Kissing Point Ferry Wharf Upgrade

Submissions report

Transport for NSW | March 2020

An overview of the Proposal is shown in Figure 1.

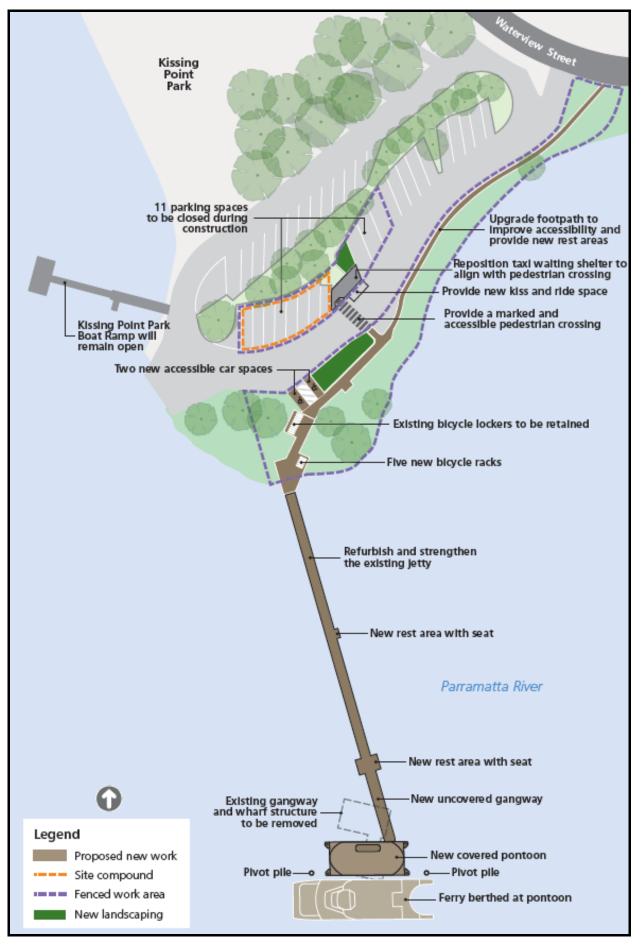
Four submissions critiqued the overall design of the wharf and provided feedback, criticism and concerns. While both positive and negative responses were received, the submissions report has addressed legitimate concerns/shortfalls in the design of the wharf. The concerns raised include the following:

- 1. Request for 2 bollards to be placed on each bay for upstream and downstream services;
- 2. Hard steel cornered pontoon are an issue for smaller vessels;
- 3. Hard steel cornered fenders are unsympathetic for vessels;
- 4. Design only caters for Sydney Ferry length vessels;
- 5. Challenging tidal conditions. Suggested elbow cleats on pivot piles;
- 6. Request for entry and exit barriers on the gangway;
- 7. Request for lighting along the full length of the jetty;
- 8. Appropriate fishing signage and enforcement;
- 9. Touch screen kiosk to supplement existing Ferry Operation and Communication Information System (FOCIS) screens;
- 10. Opal readers located on the pontoon rather than the jetty;

- 11. Safety of children due to the lack of barriers;
- 12. Concerned about the impact of pontoon's orientation for ferries on tidal movements, ferry operations and on the river;
- 13. Unnecessary installation of bicycle racks.

- 1. Bollards have been included in the wharf design with two bollards per fender for a total of six bollards on the berthing face on the southern side of the pontoon;

- 2. Recreational berthing for smaller vessels on the pontoon will not be provided due to challenging bathymetric and tidal conditions in this area. Recreational vessels and water taxi's may berth at the public wharf adjacent to the Kissing Point Ferry Wharf in Kissing Point Park;

- 3. The project team has designed the fender system in consultation with Transdev Sydney Ferries to accommodate operational requirements;
- 4. The wharf has been designed to cater for 200 tonne vessels. The dimensions of the pontoon is determined by a number of factors, including the low patronage numbers;

- The project team has designed the wharf orientation in consultation with Transdev Sydney Ferries to determine the optimal berthing angle to minimise tidal impacts during vessel berthing. Elbow cleats was considered during design but was not considered further due to design and operational challenges;

- 6. Entry and exit barriers on the gangway were not considered necessary in the wharf design due to the patronage numbers obtained from Opal. Furthermore, ferry operators did not request this feature during stakeholder consultation.

- 7. The lighting will be provided for the full length of the jetty as part of the upgrade;
- 8. Fishing is restricted on the wharf. New signage specifying restricted fishing hours will be included as part of the upgrade;

- 9. Touch screen kiosks are not part of the standard Transdev Sydney Ferries equipment requirements, therefore will not be provided;
- 10. Opal card readers are required to be mounted onto a fixed non-moving structure. The opal card readers are located at the viewing platform as close to the pontoon and gangway as possible;

- 11. The Kissing Point Wharf pontoon is a standard design that has been designed to create a distinctive theme for Sydney Harbour. The design is compliant with maritime related Australian Standards. TfNSW recommends children be supervised by parents and/or guardians at all times while on the pontoon;

- 12. The project team has had extensive consultation with Transdev Sydney Ferries in selecting an orientation that minimises impacts on tidal movements and on the river and satisfies operational requirements;

13. Bicycle racks are an interchange requirement as part of the ferry wharf upgrade program to allow for seamless transitions between different transport modes.
